OXFORDSHIRE RAILFREIGHT INTERCHANGE LIMITED

TECHNICAL NOTE 5: M40 JUNCTION 10 OPTIONS REPORT ADDENDUM:
RESPONSE TO NATIONAL HIGHWAYS INITIAL
COMMENTS ON OPTIONS 11, 13, 18 AND 19

project number: ADC1794				report reference: ADC1794-RP-M1
version	date	lead author	reviewer(s)	comments
1		Mark Higgins & Simon Hilditch	Stuart Dunhill	internal draft
2	08/10/2021	Mark Higgins & Simon Hilditch	Stuart Dunhill	issue to Transport Working Group

Padbury –T-junction mitigation scheme (P-4)

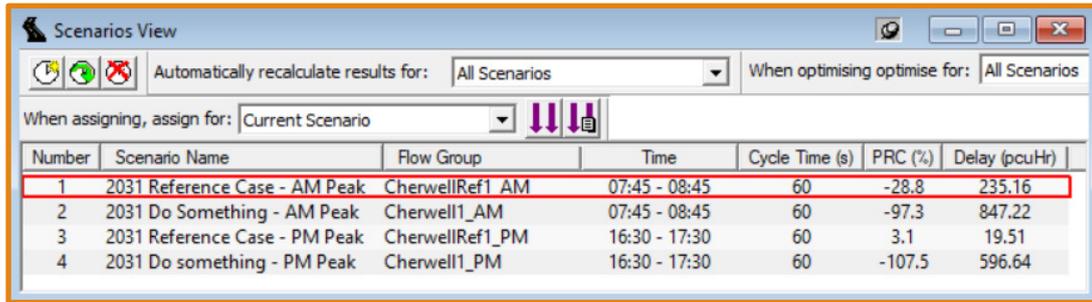
- 3.17 National Highways have audited the committed scheme LinSig model and the audit report is provided at **Appendix E**. The issues raised in the Padbury T-junction scheme model audit included consistency in the approach to saturation flows and changes to some intergreens. The issues raised have been considered and appropriate amendments to the model have been made, as logged in the model audit report provided at **Appendix E**. The revised Padbury T-junction mitigation scheme model results are provided at **Appendix E** (the .lsg3x file will be provided via email) and the results are summarised below.

- 3.18 As shown, the revised model forecasts that for both the 2031 morning and evening peak hours, the junction would operate acceptably with the development in place. Therefore, as concluded in TN5, the proposed mitigation proposal would provide a better than nil-detriment improvement when compared to the committed scheme.

Cherwell Roundabout – mitigation (C-5)

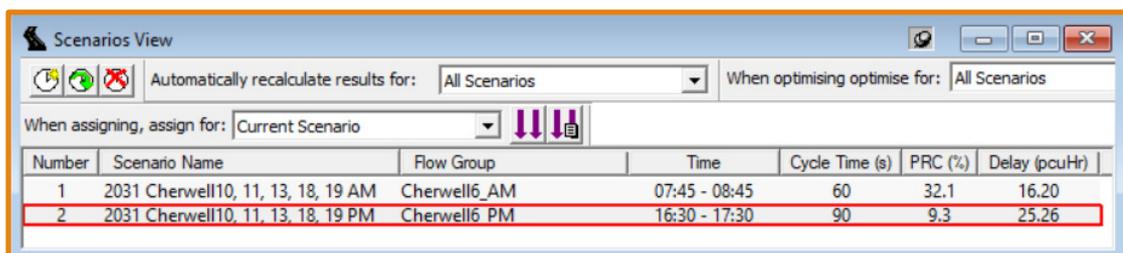
- 3.25 National Highways have audited the proposed mitigation scheme LinSig model and the audit report is provided at **Appendix G**. The issues raised in the mitigation scheme model audit included changes to a flare length and consistency in the approach to saturation. The issues raised have been considered and appropriate amendments to the model have been made, as logged in the model audit report provided at **Appendix G**. The revised Cherwell mitigation scheme model results are provided at **Appendix G** (the .lsg3x file will be provided via email) and the results are summarised below.

- 3.26 As shown, the revised model forecasts that for both the 2031 morning and evening peak hours, the junction would operate acceptably with the development in place. Therefore, as concluded

in TN5, the proposed mitigation proposal would provide a better than nil-detriment improvement when compared to the committed scheme.

Project:	Oxfordshire SRFI
Title:	Padbury T-junction option
Location:	
Additional detail:	Amended following Aecom comments
File name:	211006 Padbury - P-4 T-junction option.lsg3x
Author:	Mark Higgins
Company:	ADC Infrastructure
Address:	Nottingham

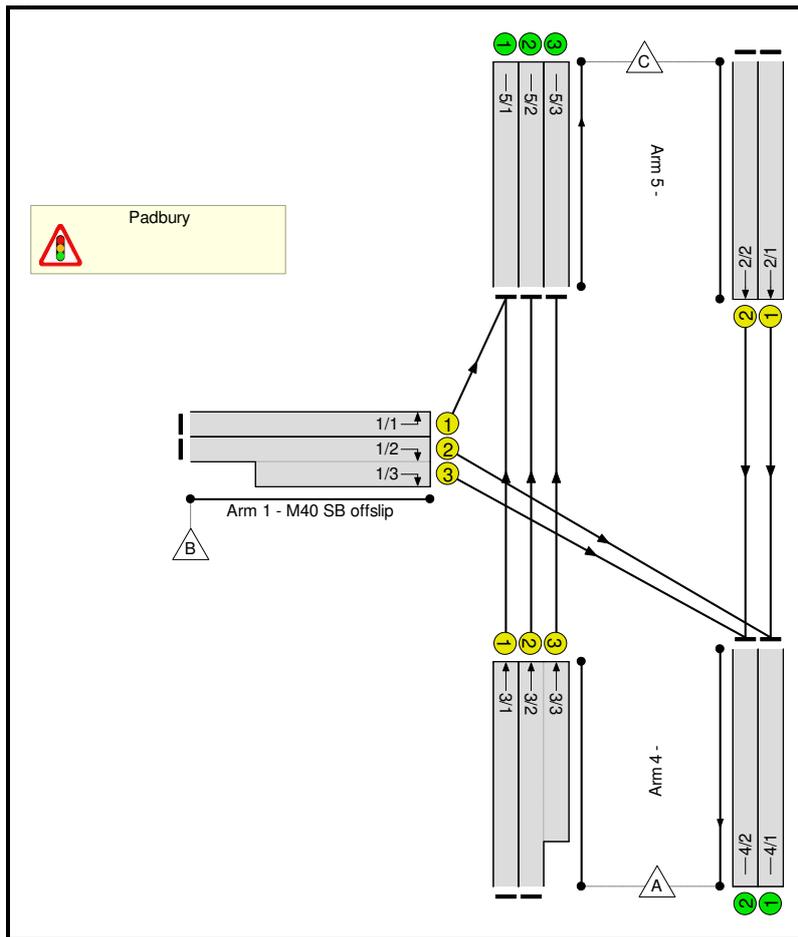
26/07/21	Check external sat flows calculations (if used)				
26/07/21	Check sat flows for any bottleneck links	✘	Please check the Arm5. After exam the drawing Arm 5 lane 3 will be merging into lane 2 after 100mtr. Hence, lane sat flow should be coded on Arm 5 to limit the flow distribution on lane 3 to reflect the realist driving behaviours.	Saturation flow applied to Arm 5 lane 3 to alter traffic assignment in the merging lane.	
	Advanced Lane Settings				
26/07/21	Use of start / end green displacements (if req)	✓	Default values used.		
26/07/21	Use of queue limits on short links (if req)	N/A			
26/07/21	Use of weightings for optimiser constraints (if req)	N/A			
26/07/21	Use of random delay or queue de-sliver (if req)	N/A			
	Give Ways				
26/07/21	Check each lane that is priority controlled	N/A			
26/07/21	Measurement of max/min flow when giving way	N/A			
26/07/21	Flow when opposing traffic stopped reasonable	N/A

26/07/21	Stages reasonable	✓			
26/07/21	Phase delays reasonable (if req)	?	Phase delays might be required after the above inter-green amendment.	3 second losing phase delay added to phase A on stage change 1-2.
